Subject: Revised DEIR Public Comments Regarding the DEIR Chapter 2.8 Noise with regard to the Proposed Accretive Lilac Hills Ranch General Plan Amendment and Specific Plan PDS2012-3800-12-001(GPA),PDS2012-3810-12-001 (SP).

Subject: DEIR Public Comment to the Proposed Accretive Lilac Hills Ranch General Plan Amendment and Specific Plan PDS2012-3800-12-001(GPA), PDS2012-3810-12-001 (SP), DEIR Chapter 2.8 Noise

Subject: DEIR Public Comment to the Proposed Accretive Lilac Hills Ranch General Plan Amendment and Specific Plan PDS2012-3800-12-001(GPA), PDS2012-3810-12-001 (SP), DEIR Chapter 2.8 Noise; Noise Report of the proposed Lilac Hills Ranch (LHR) Project

FIGURE 6a

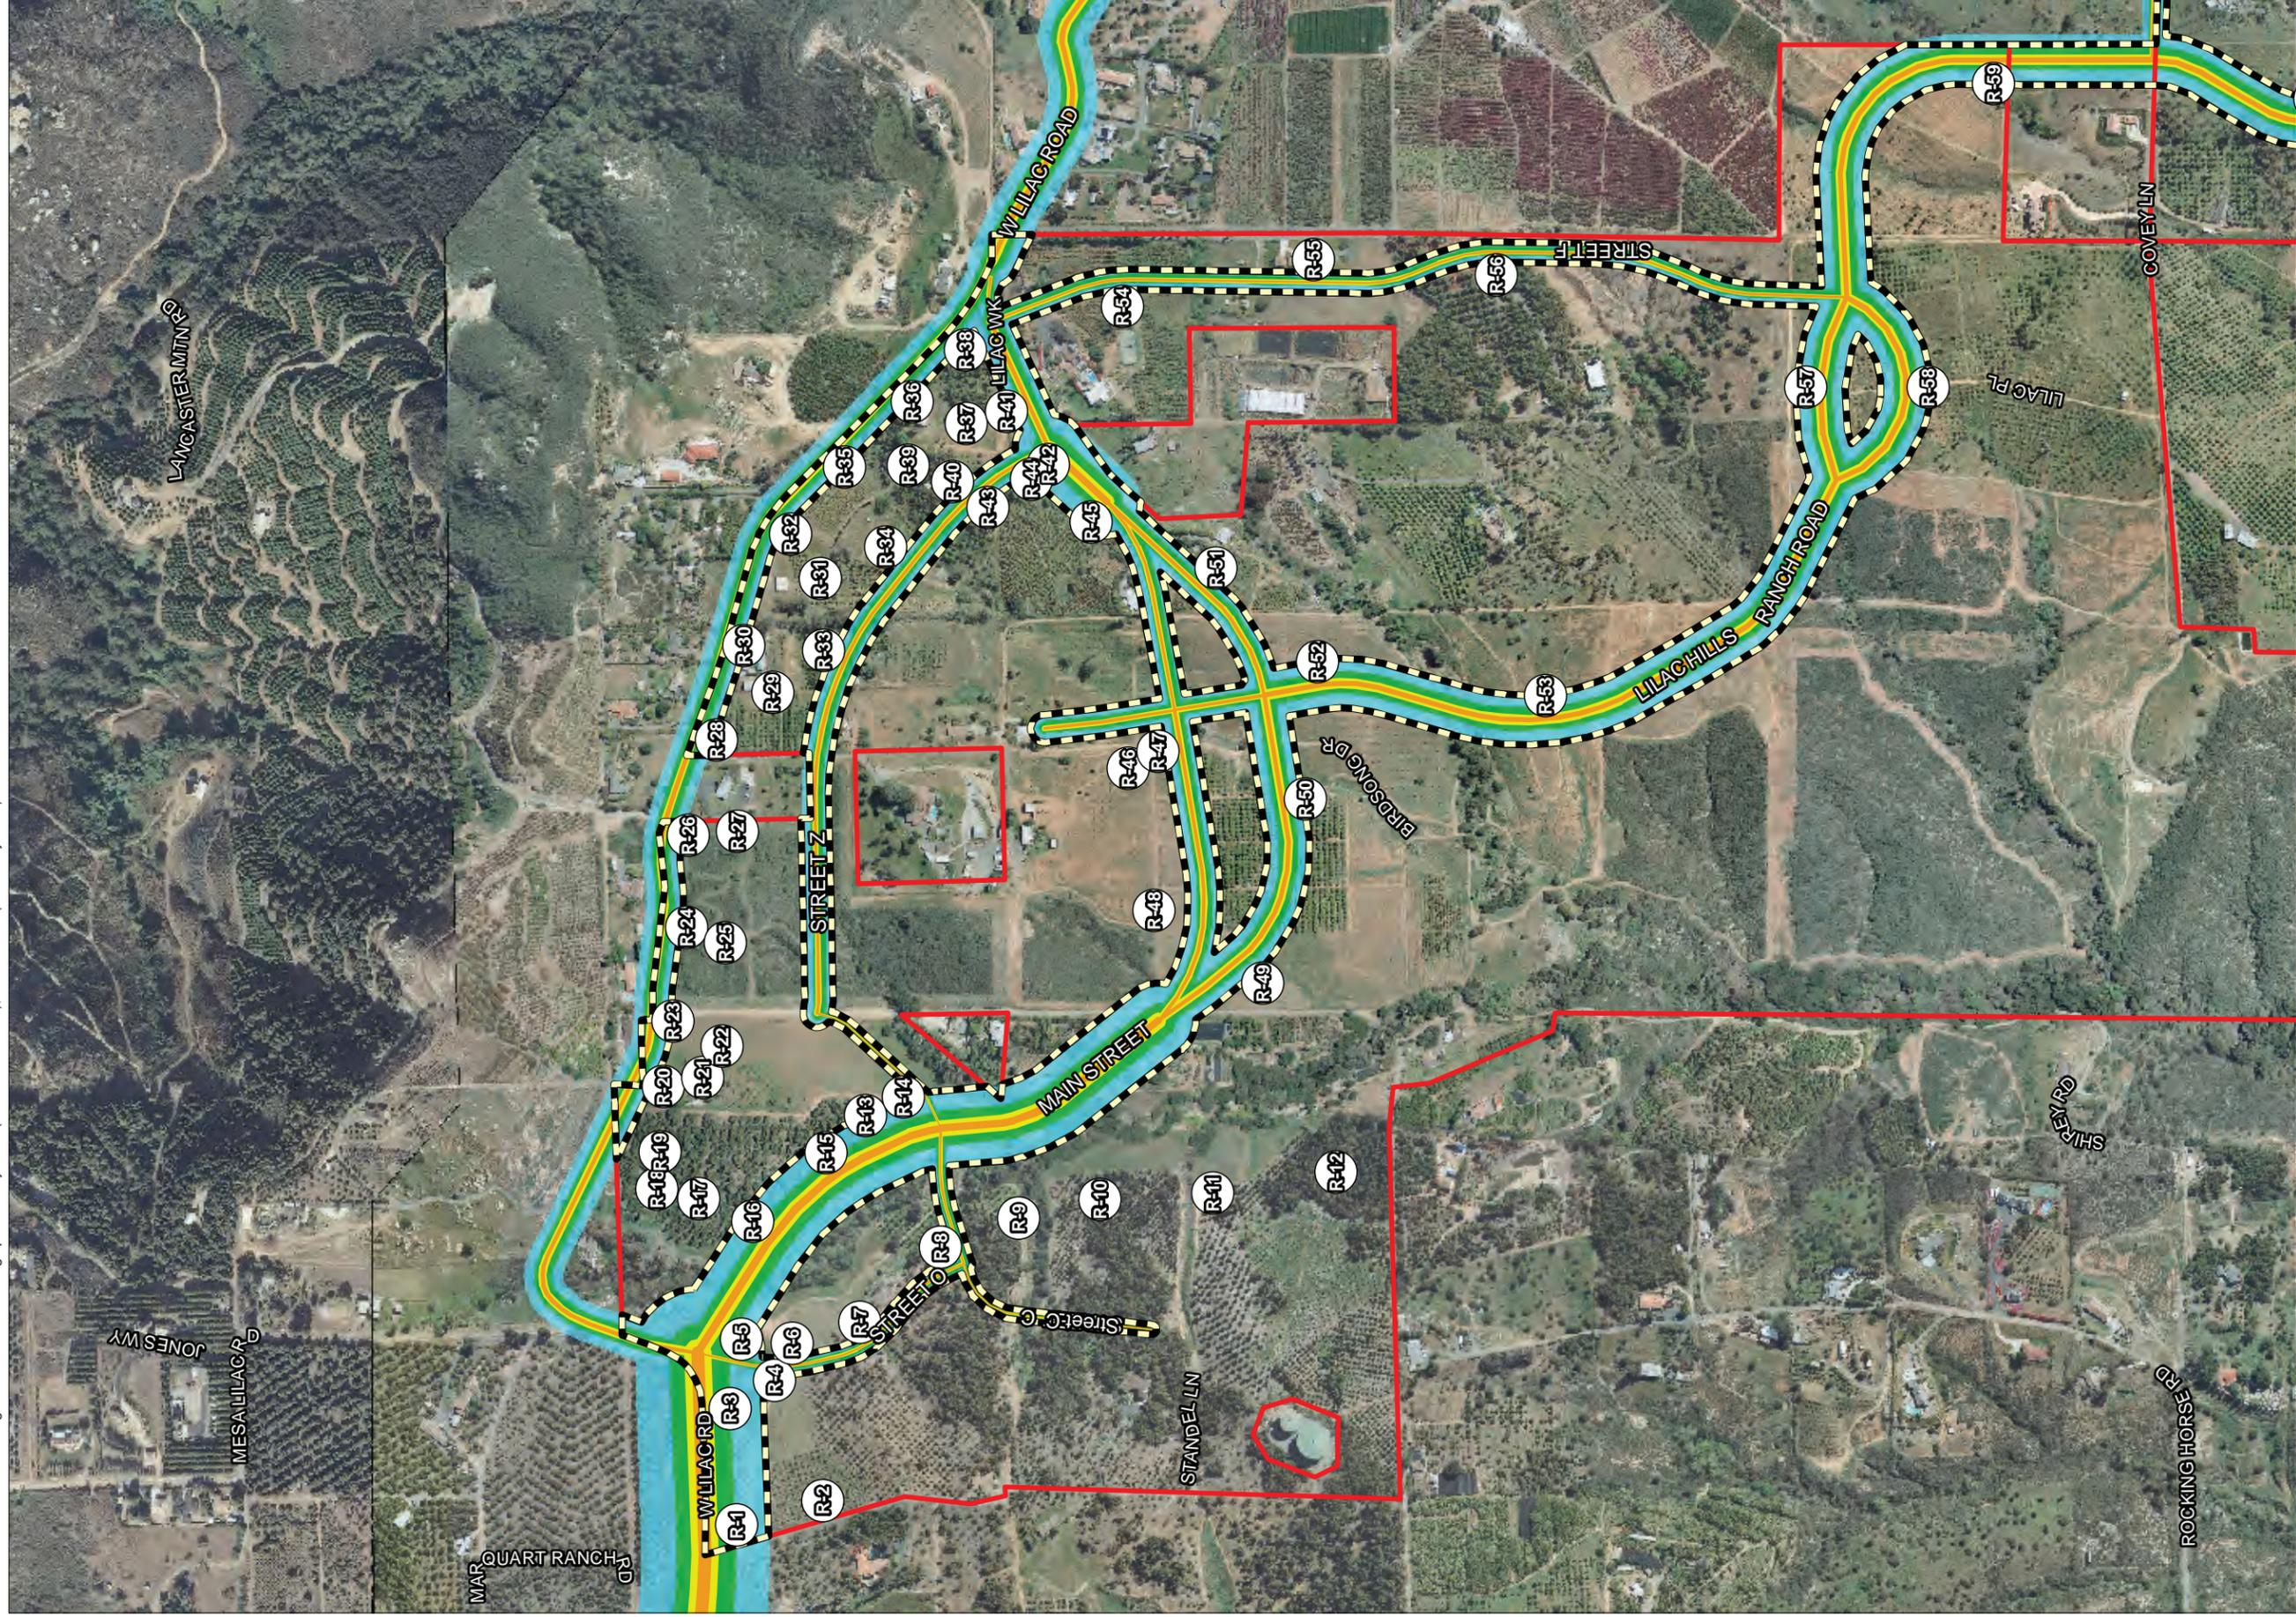
Also, Figures 6a and 6b geo-locate On-Site Local Receiver locations, and provide a reference back to Table 12. Figure 7 for Off-Site Local Receivers does not label Local Receivers with a reference back to Table 12. Remedy this by labeling Figure 7 Off-Site Receivers with a reference back to Table 12. Also, include a Table in similar format to Table 9 which cross references Off-Site Local Receivers to map locations.

FIGURE 6b

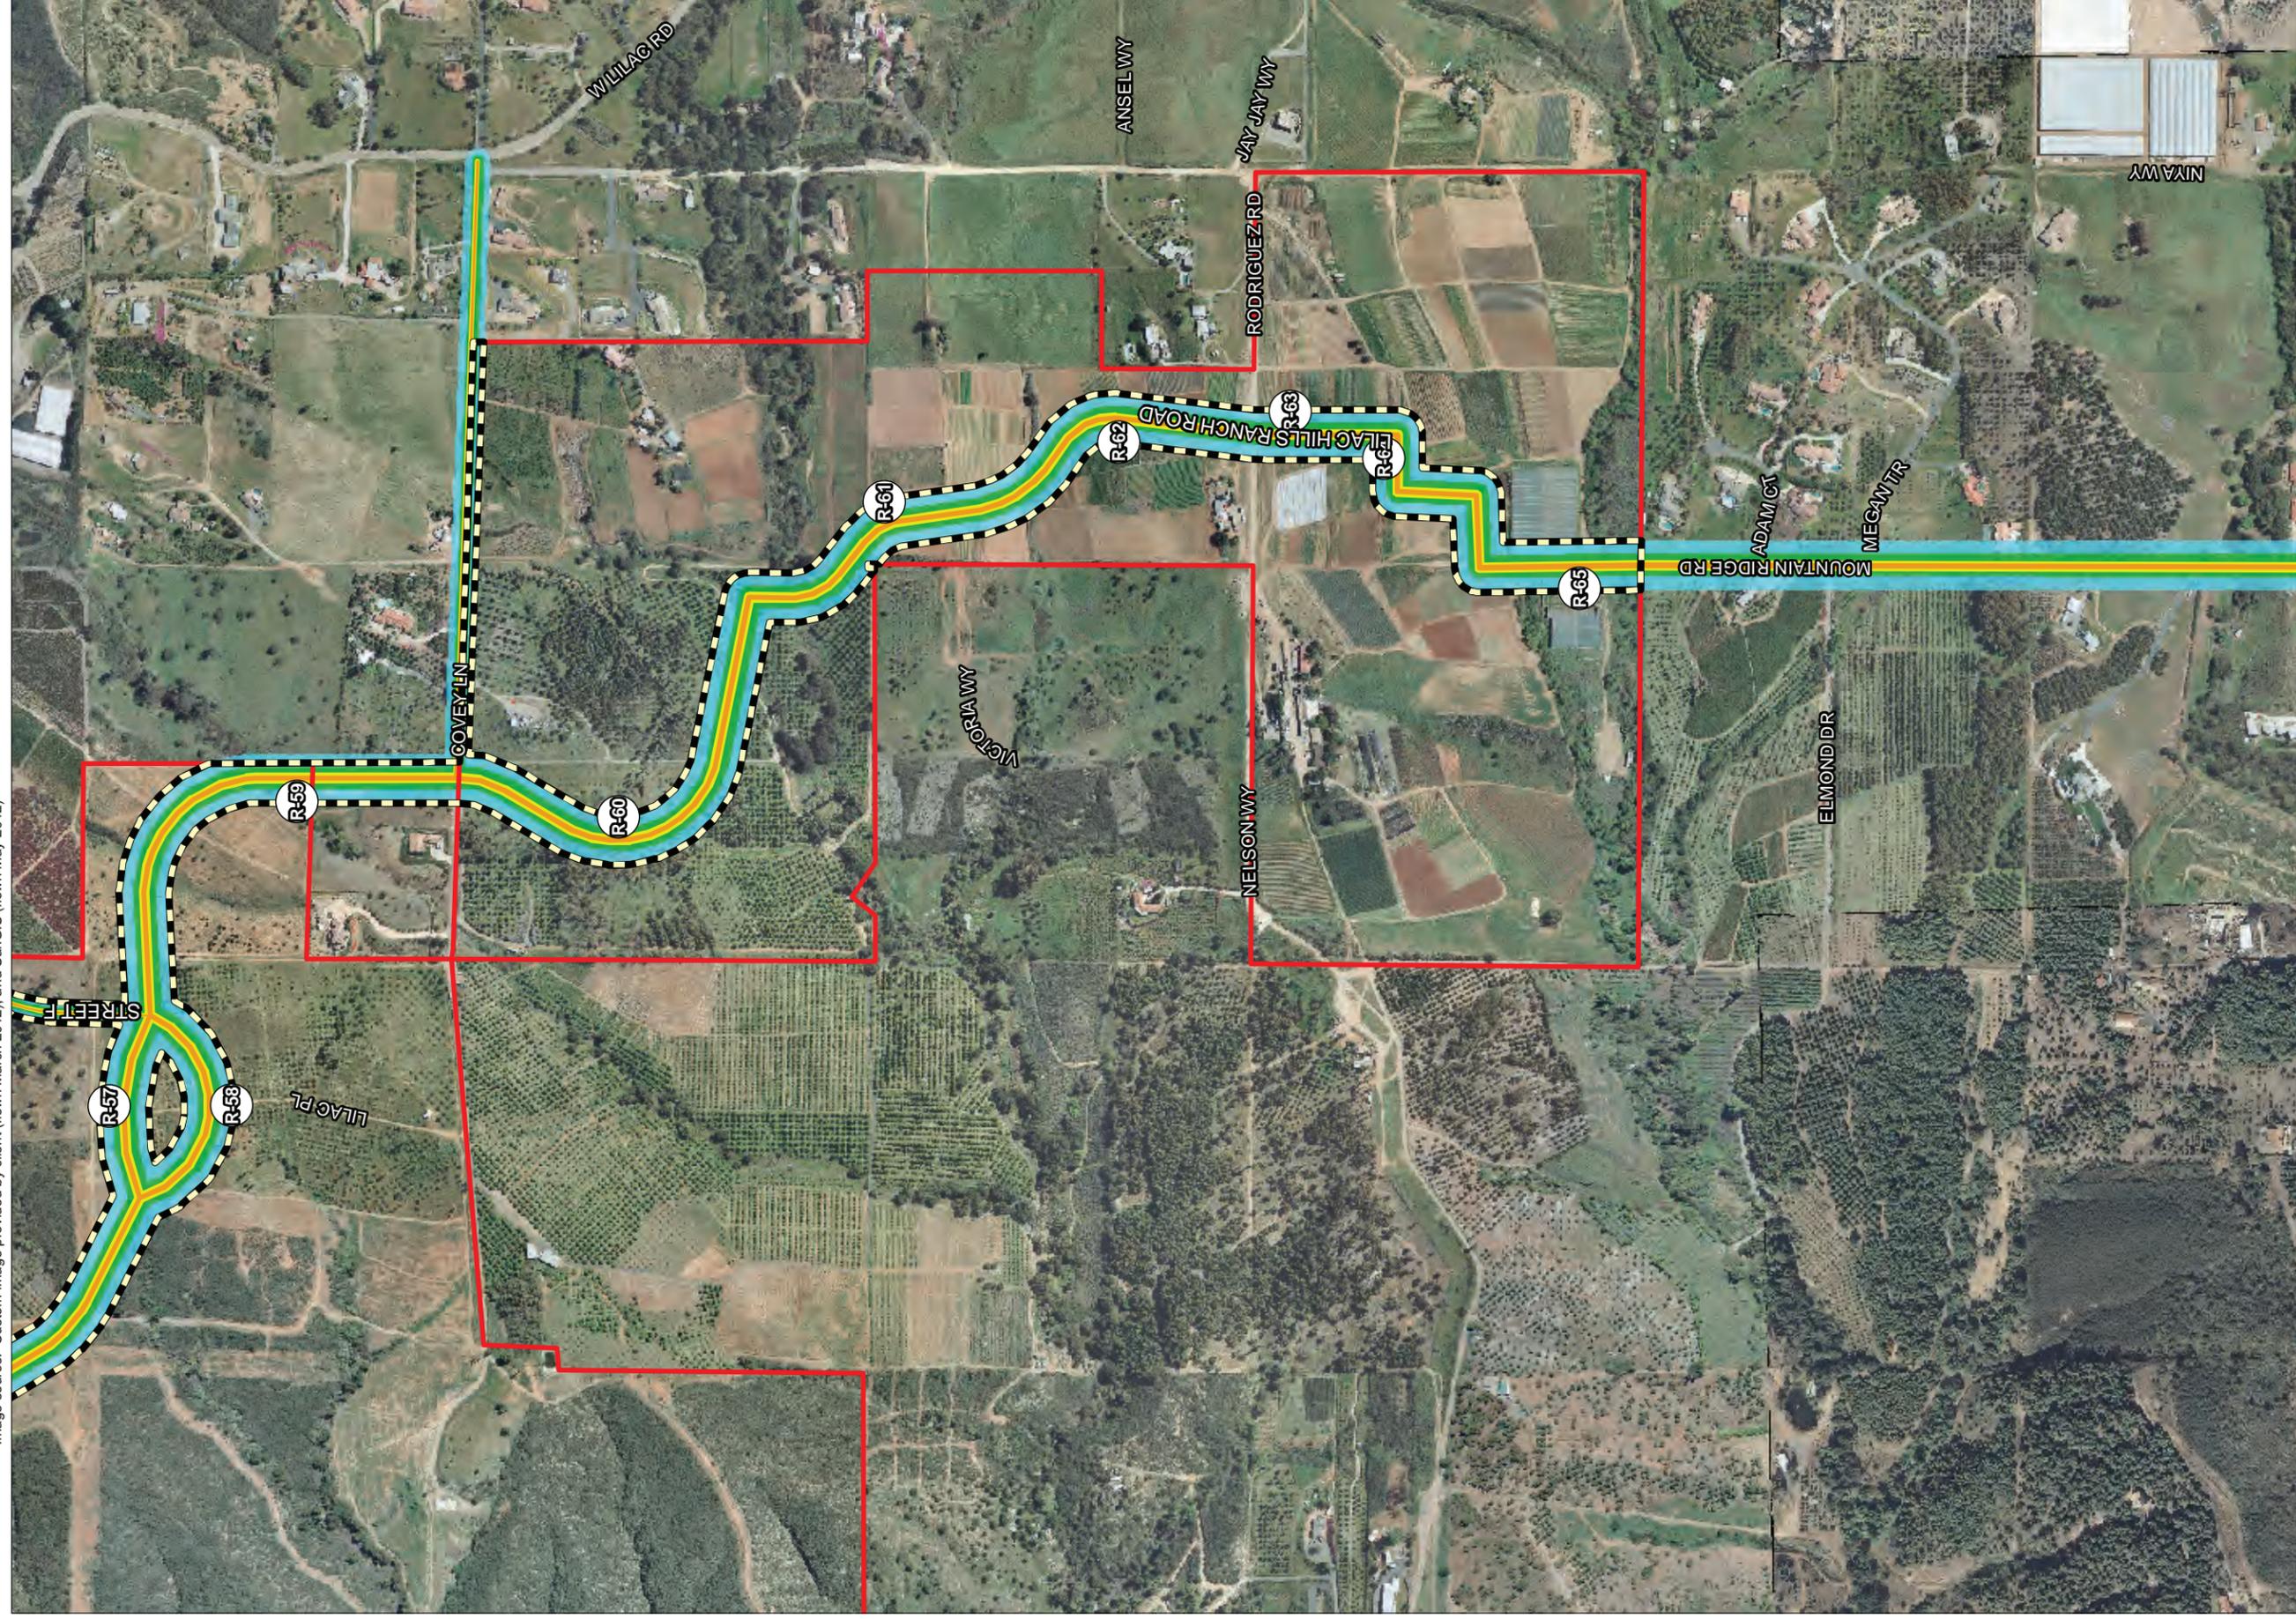
For example, the modeled results in Table 12 of Appendix M- Noise Report for APN 129-430-13 (Receptor R-150) conflict with the 60 and 65 CNEL noise contour presented in FIGURE 6-b in Appendix M (Attachment 1). We challenge the County's representation that future cumulative noise level at 57 CNEL for location R-150, since the residence is in the path of the 65 CNEL contour in FIGURE 6-b in Attachment 1.

Appendix Figure 1
Noise Mitigation Evaluation - West Lilac Road

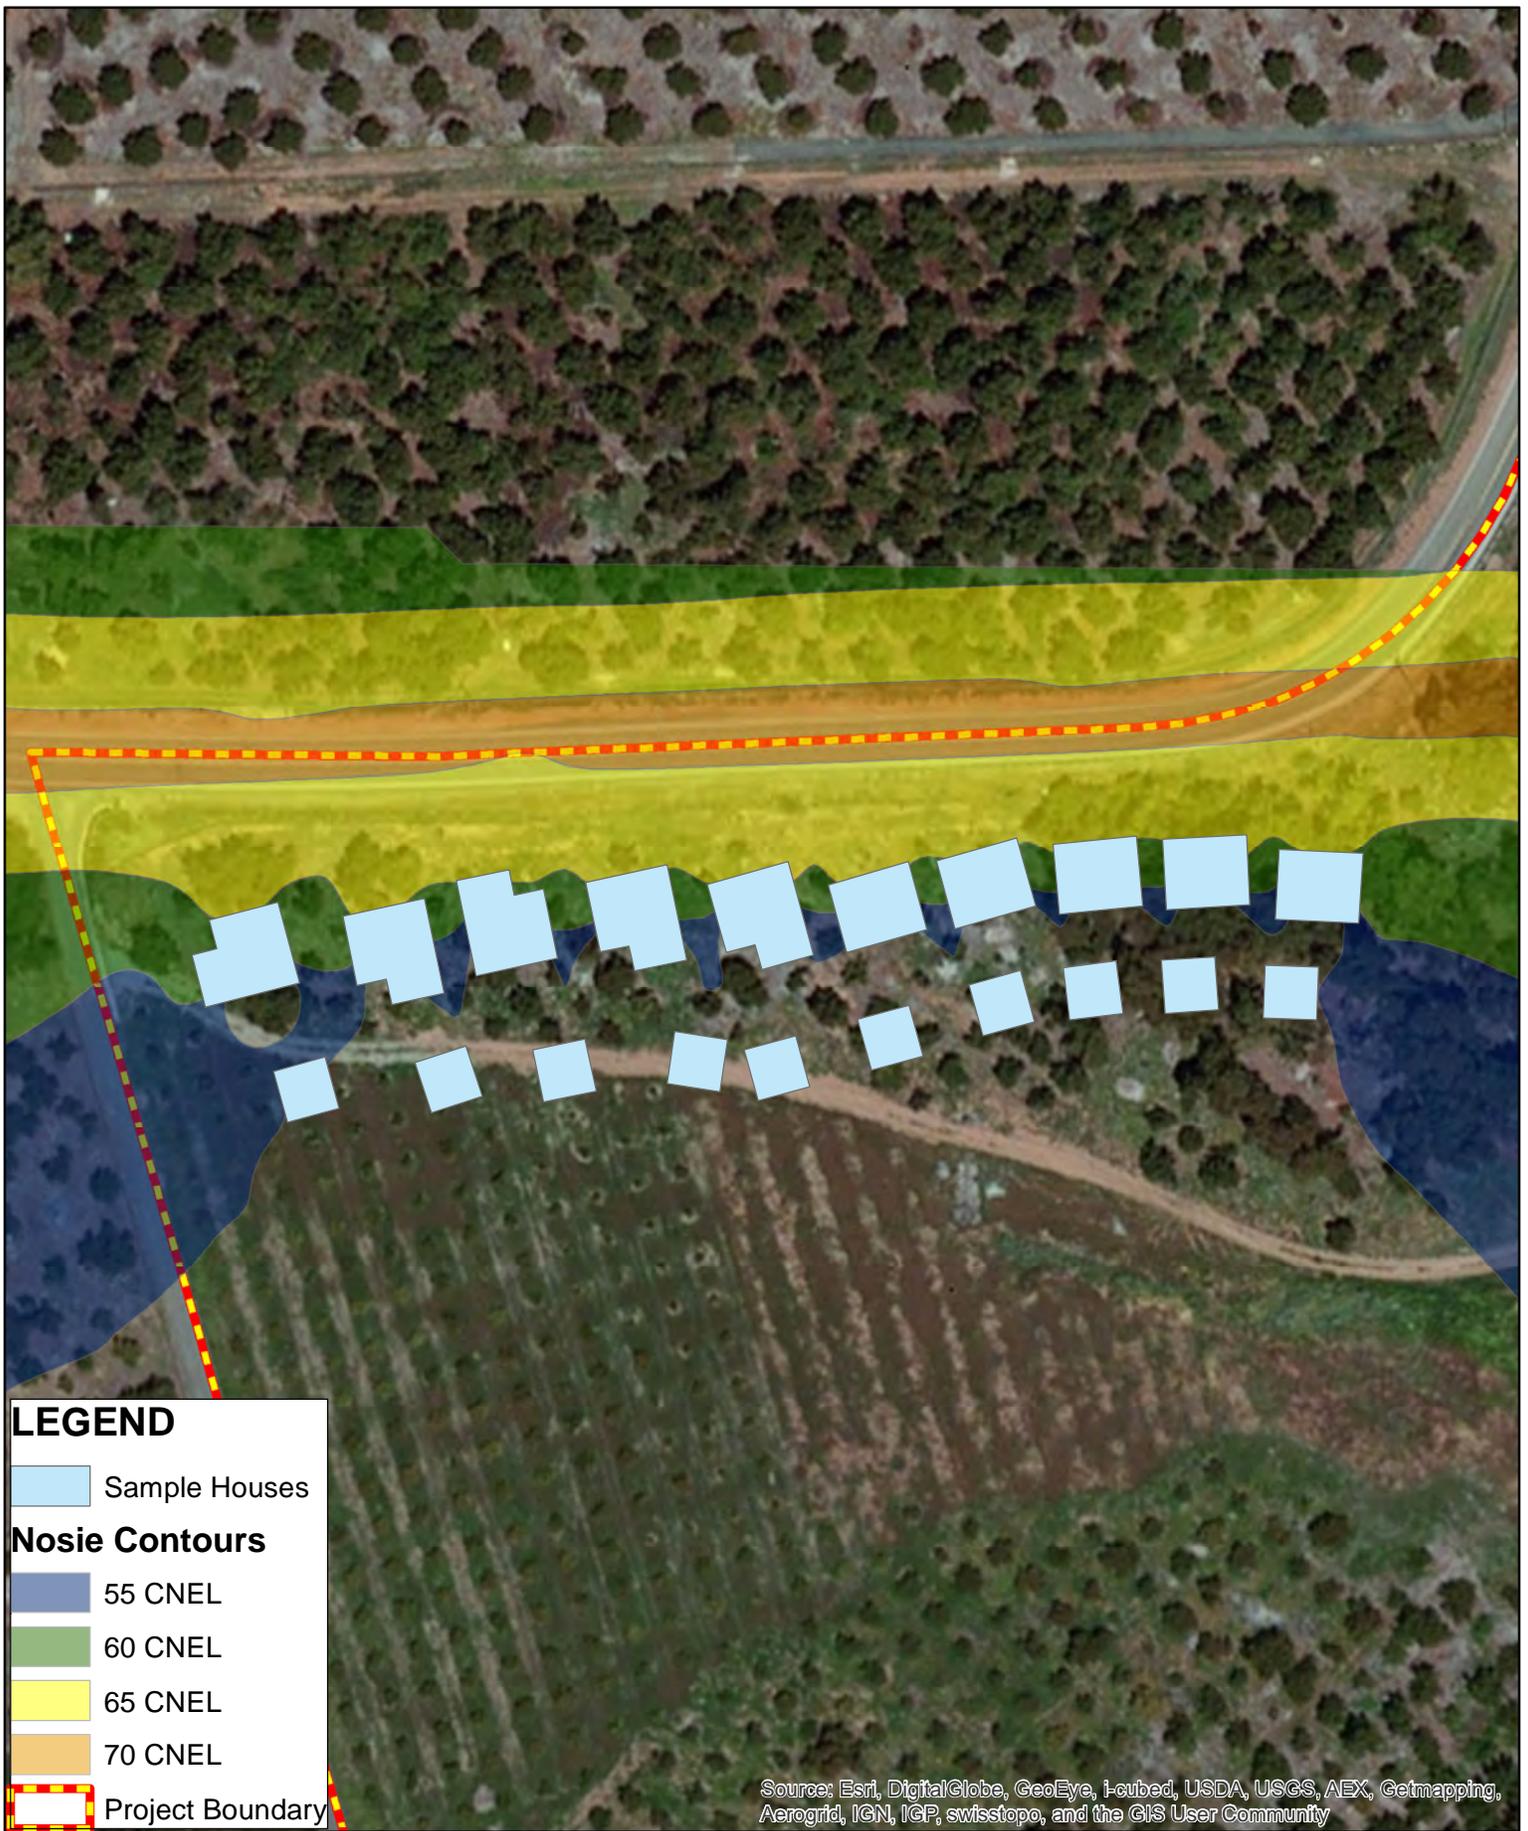
The County's lack of independent analysis is evident in the DEIR assessment of Noise Impacts. The Project's single point "offsite noise modeling" (Attachment 2) selects a point along West Lilac where there are no existing houses. The Project claims that they have (maybe) set back future Project residential housing **within the subdivision boundaries** from the 65 CNEL contour.

How about the impact on existing homes? Why wasn't a stretch of West Lilac further east with existing housing selected for analysis?

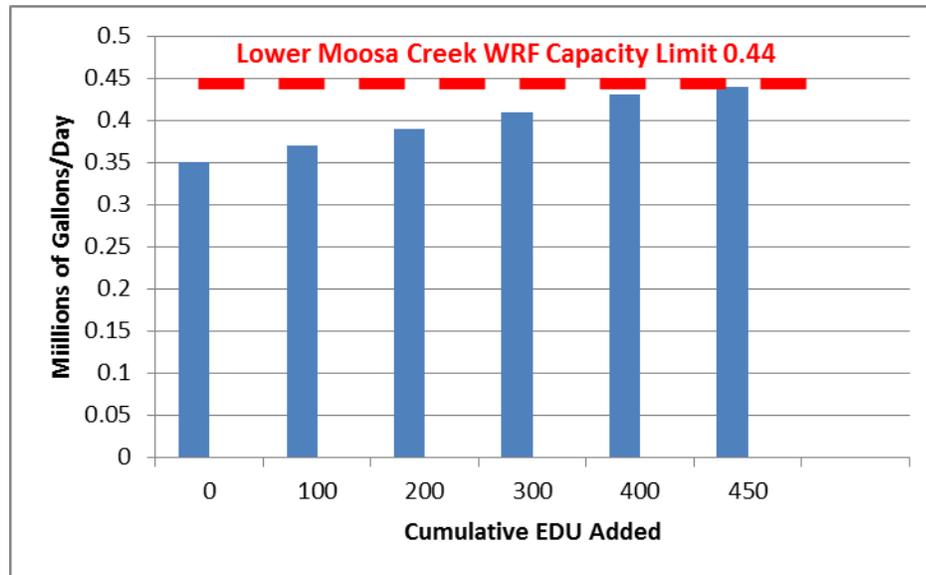
The present capacity of LMWRF allows addition of a maximum of 450 Equivalent Dwelling Units (EDU's) until secondary percolation ponds are at full permit capacity. See Graph below:

Question 5): It is our understanding that the Regional Water Quality Control Board (RWQCB) may not allow an expansion to the current 0.44 MGD limit on the percolation ponds. Is this correct? In your response, please provide details of current Basin and Sub Basin capacity, present Surface and Groundwater Quality (detail of TDS by element, heavy metals, and biological organisms) for relevant Basins and Sub Basins. Please provide RWQCB's detailed analysis of concerns on any proposed expansion of the LMWRF percolation pond capacity for additional disposal of secondary disinfected recycled water beyond the current 0.44 MGD cap.
